Addendum No. 1

Rock River Water Reclamation District Clarifier Railings (Primary Clarifier Tanks 5 – 10) Capital Project No. 1706

This Addendum Number 1, dated August 13, 2018, for the above referenced project, supersedes all contrary and conflicting information in the specifications and contract documents, which are hereby supplemented or revised as follows:

EXISTING CONDITIONS, DETAILS, & REMOVALS - CLARIFIERS 5-7

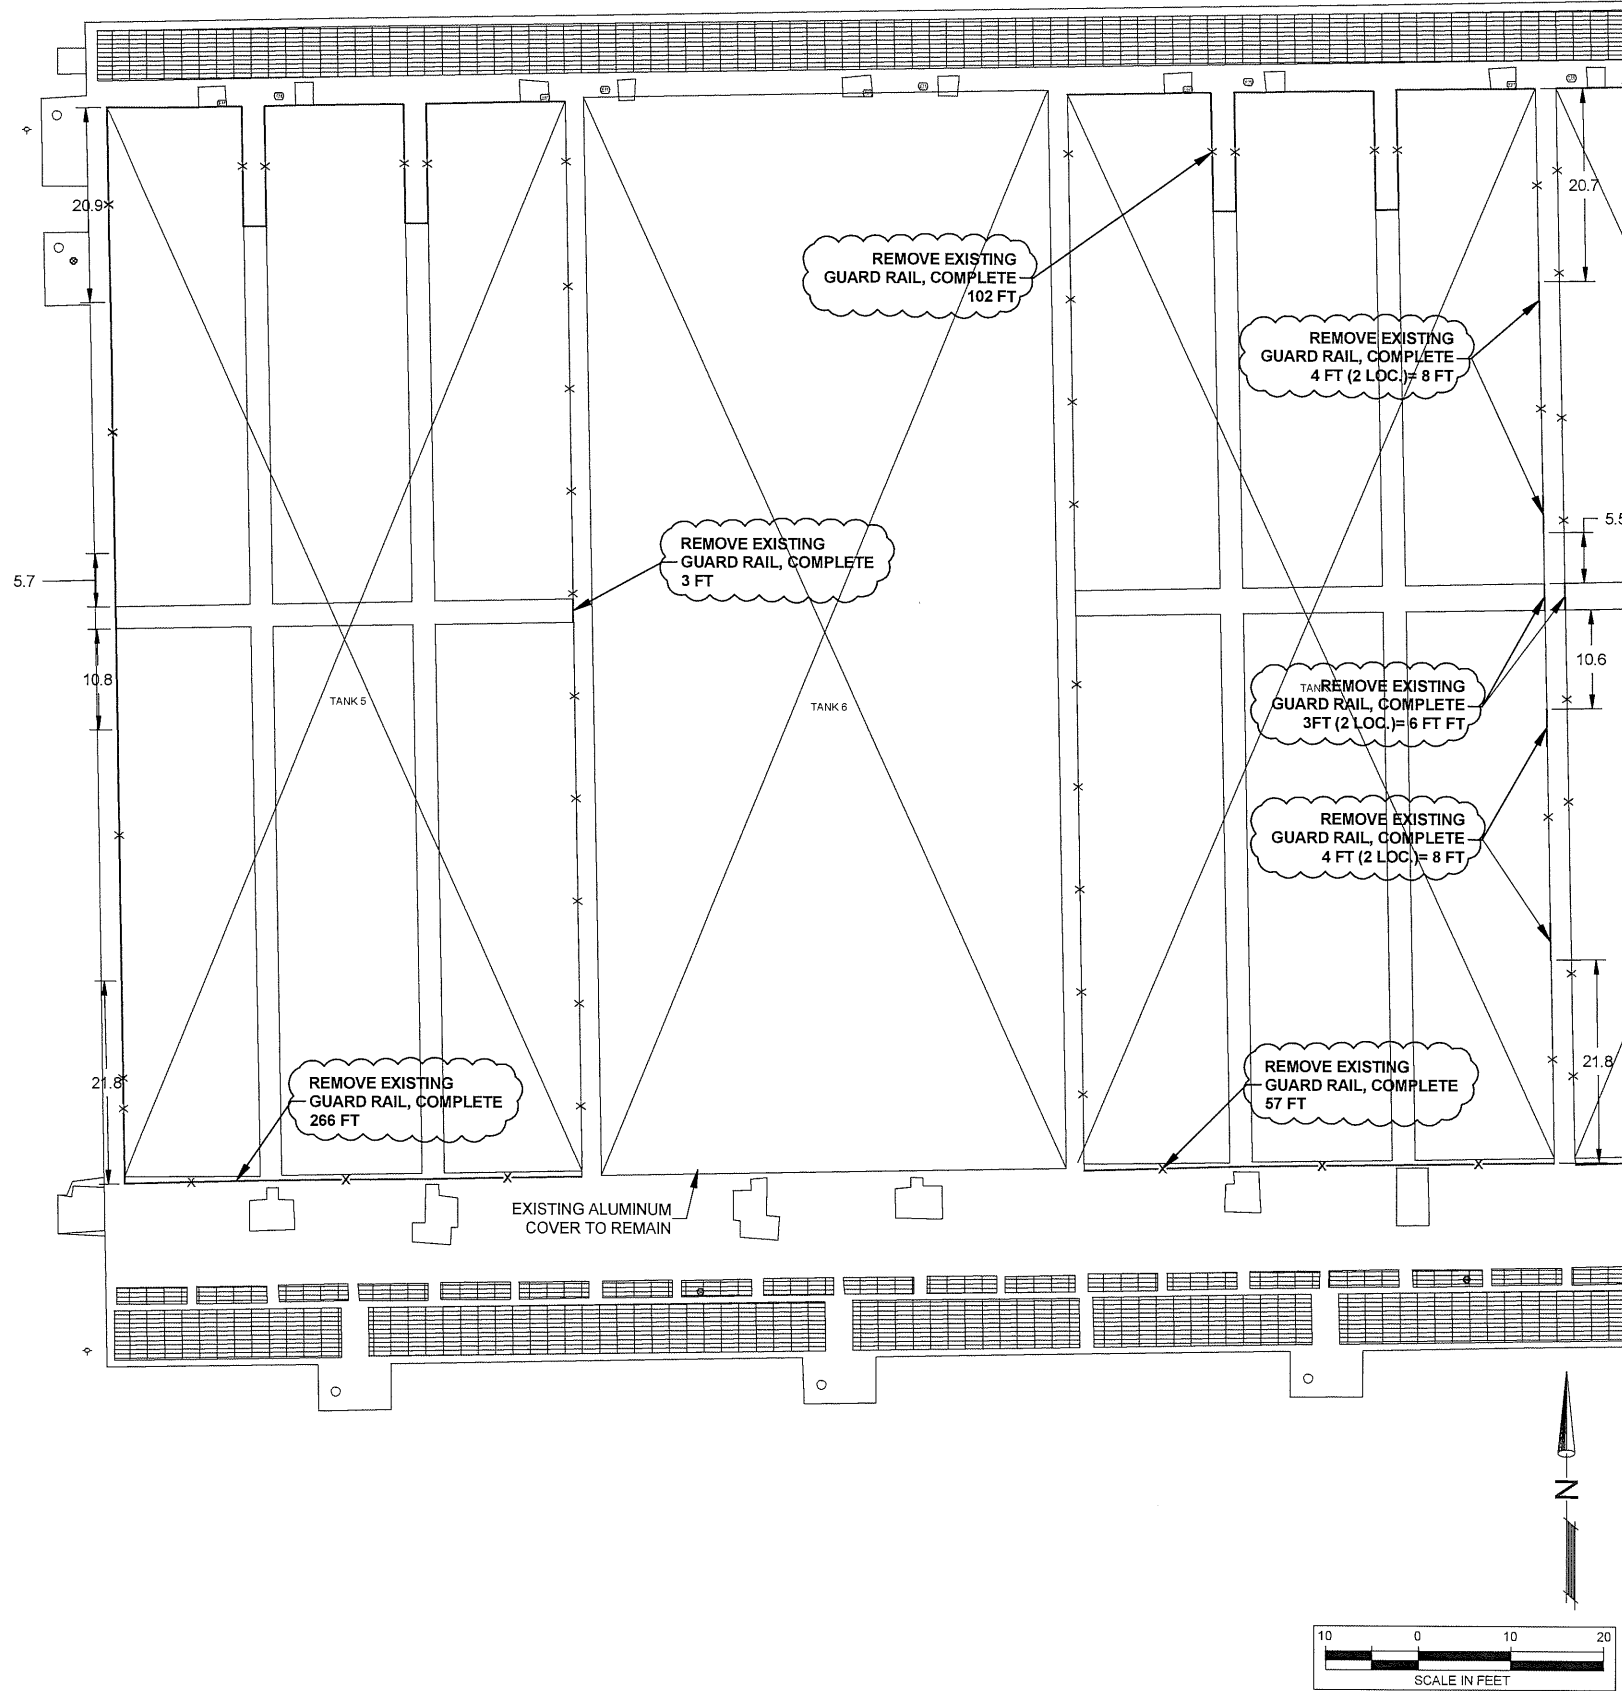
- b. Sheet 3/7 –Plan view has been updated to reflect the additional existing guard rail and toe plate to be removed.
 - c. Sheet 4/7 –Plan view has been updated to reflect the additional existing guard rail and toe plate to be removed.

PROPOSED CONDITIONS & DETAILS - CLARIFIERS 5-7

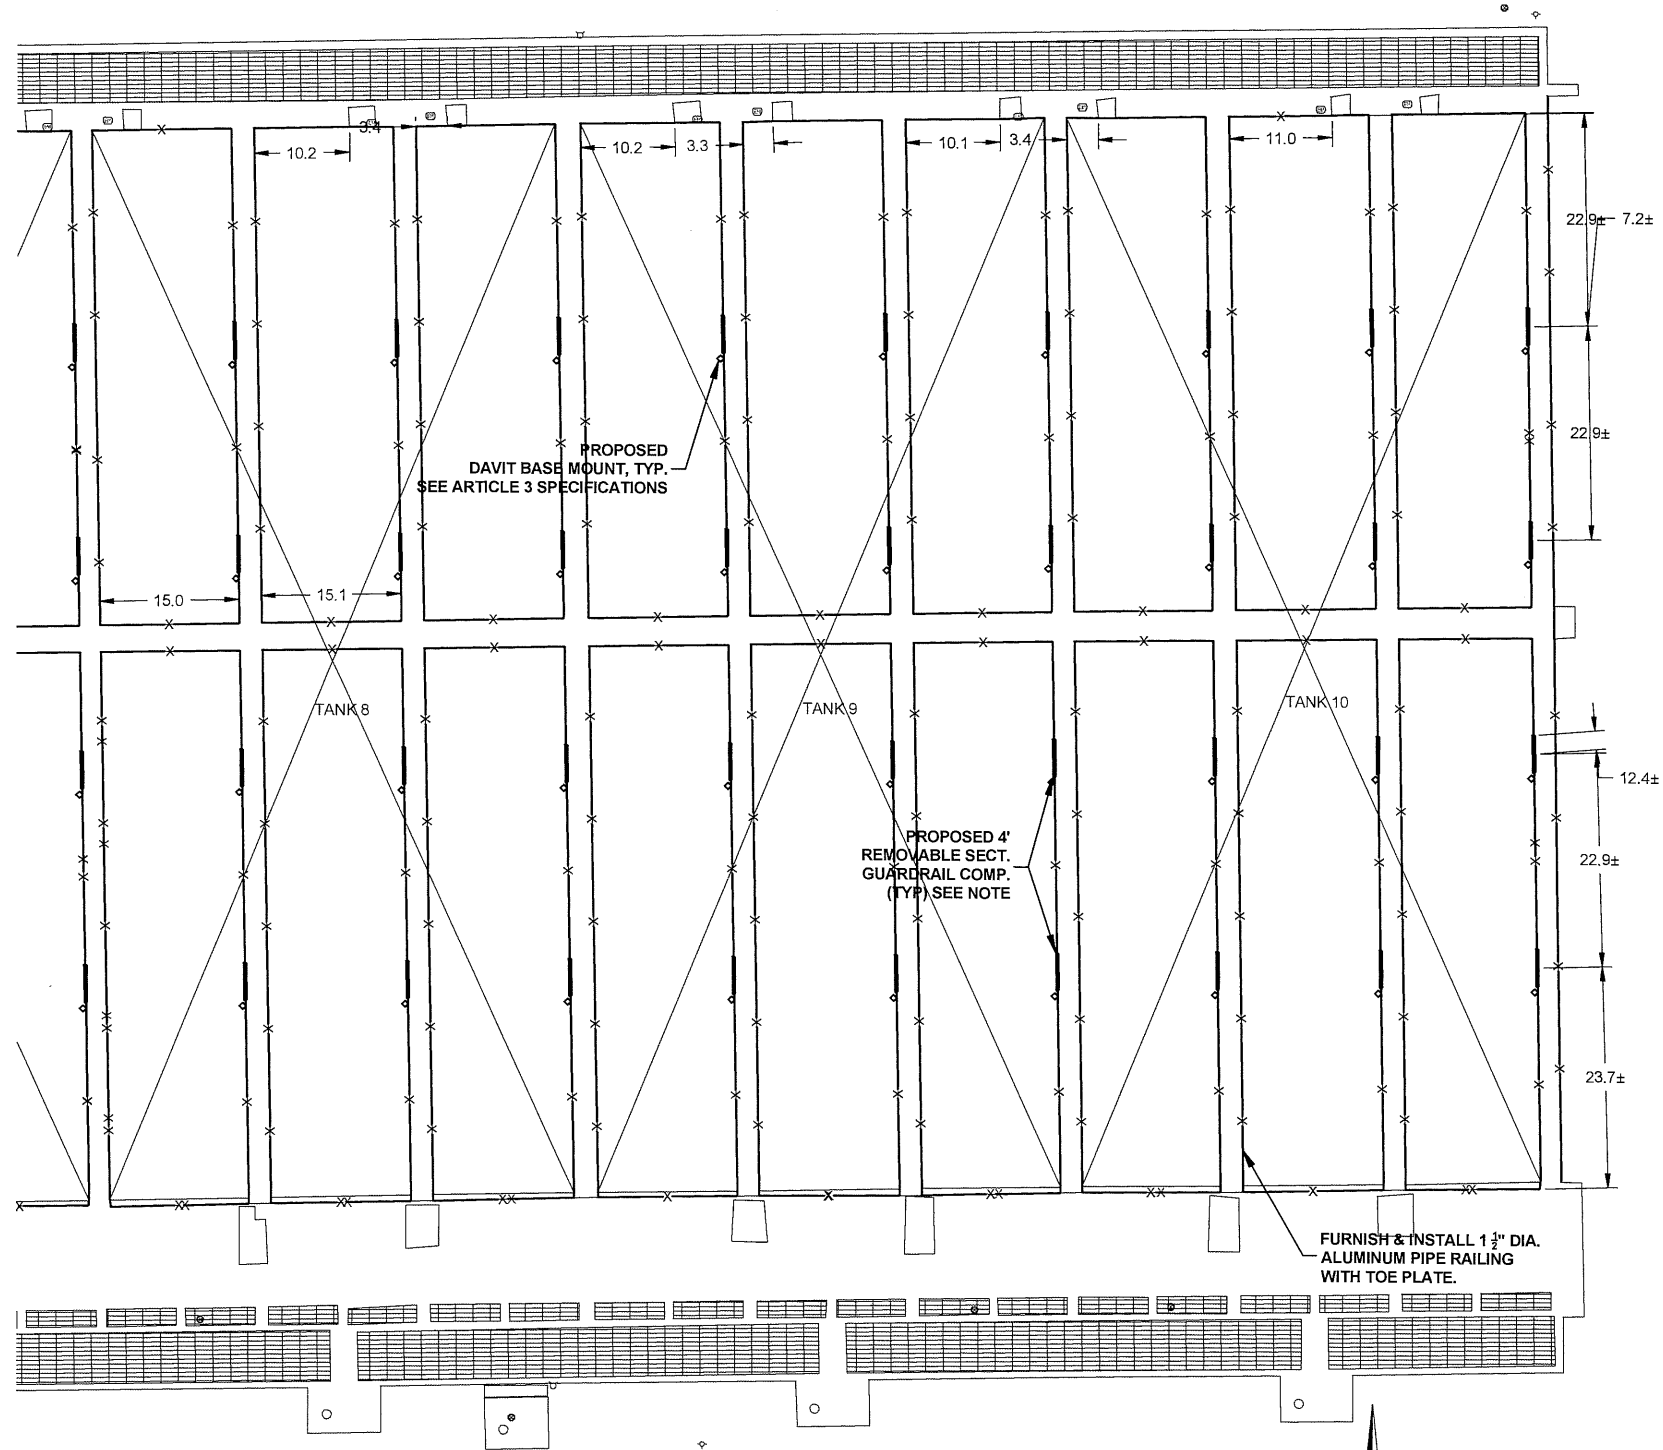
- d. Sheet 5/7 –Plan view has been updated to reflect the additional proposed guard rail and toe plate to be furnished and installed.
 - e. Sheet 6/7 –Plan view has been updated to reflect the additional proposed guard rail and toe plate to be furnished and installed.
